Transport Assessment

State Significant Development Application

Proposed Lot 10 – Kemps Creek Warehouse, Logistics and Industrial Facilities Hub

Ref: 1732r01v08 SSD TA_Proposed Lot 10_Kemps Creek
26/09/2022

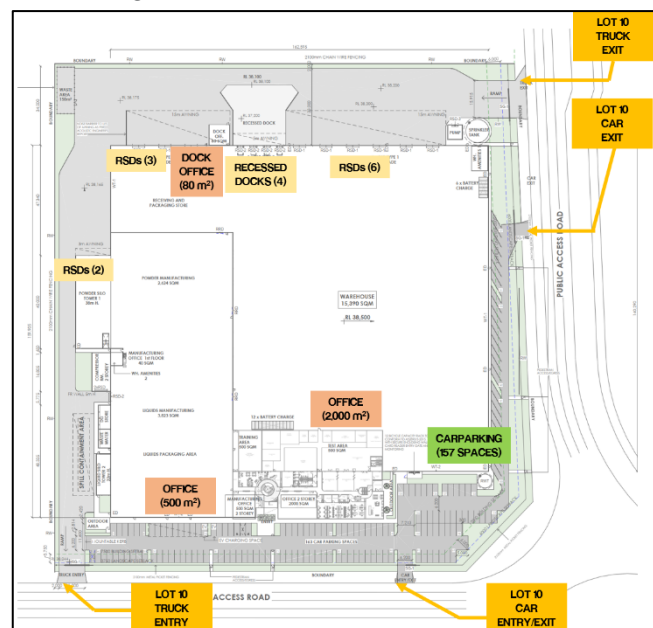
- 4 Detailed plans of all proposed site access points, justification for their location and an assessment of potential traffic impacts from the proposed access points.

Section 2 provides a detailed analysis of the proposed access points with a swept path analysis included in **Appendix D**. A copy of the access arrangement is also shown below.

Furthermore, **Section 6.7** details the impact the proposed egress point will have with regards to the Site.

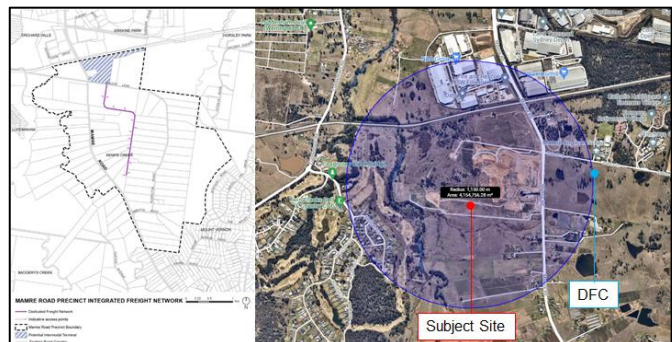
- 6 Demonstrating compliance with clause 33C of the SEPP WSEA, specifically the integration with the Mamre Road Precinct dedicated freight corridor (DFC) including provision for access from the DFC to the entire estate.

The location of the Mamre Road Precinct Dedicated Freight Corridor (DFC) is shown on the left hand side within the following figure. The subject Site is located approximately 1.15km from the Mamre Road Precinct DFC.
